SIB 61 23 20

RECALL 20V-601: HIGH-VOLTAGE BATTERY RECALL

This Service Information Bulletin (Revision 4) replaces SI B61 23 20 **dated December 2020**.

SP44 HV Battery (G05) modules

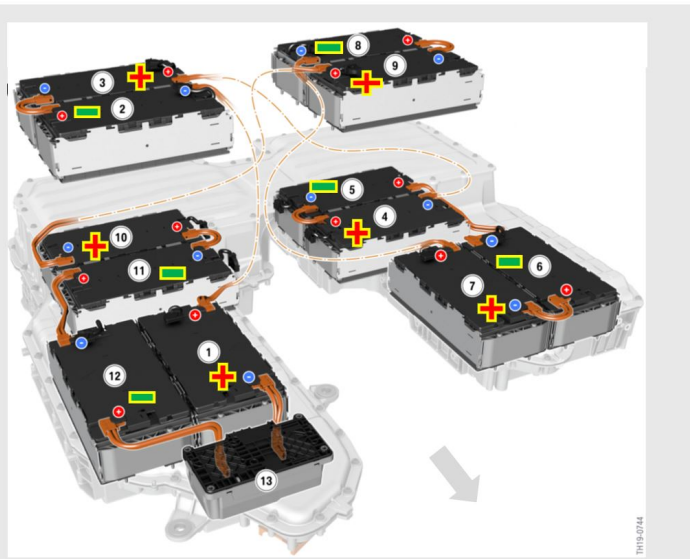
Modules are designed as Positive and Negative modules (with different orientation and part numbers). When replacing modules, verify in EPC the correct part (POS/NEG) and reinstall according to their original position. See below.

Use EPC diagram to verify the correct module part number (01/02) for NEG or POS modules.

Use the illustration on the right to match the part# with the correct module installation location.

- Module 12 is **NEG (01)**
- Module 1 is **POS (02)**
- Module 11 is **NEG (01)**
- Module 10 is **POS (02)**
- Module 2 is **NEG (01)**
- Module 3 is **POS (02)**
- Module 8 is **NEG (01)**
- Module 9 is **POS (02)**
- Module 5 is **NEG (01)**
- Module 4 is **POS (02)**
- Module 6 is **NEG (01)**
- Module 7 is **POS (02)**

SP41 HV Battery (G01/G20/G20/G12) modules

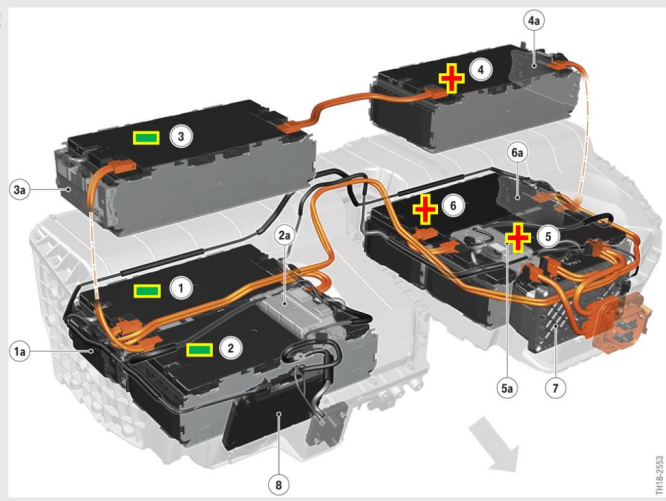
Use EPC diagram to verify the correct module part number (01/02) for NEG or POS modules.

Use the illustration on the right to match the part# with the correct module installation location.

- Module 1 is **NEG (01)**
- Module 2 is **NEG (01)**
- Module 3 is **NEG (01)**
- Module 4 is **POS (02)**
- Module 5 is **POS (02)**
- Module 6 is **POS (02)**
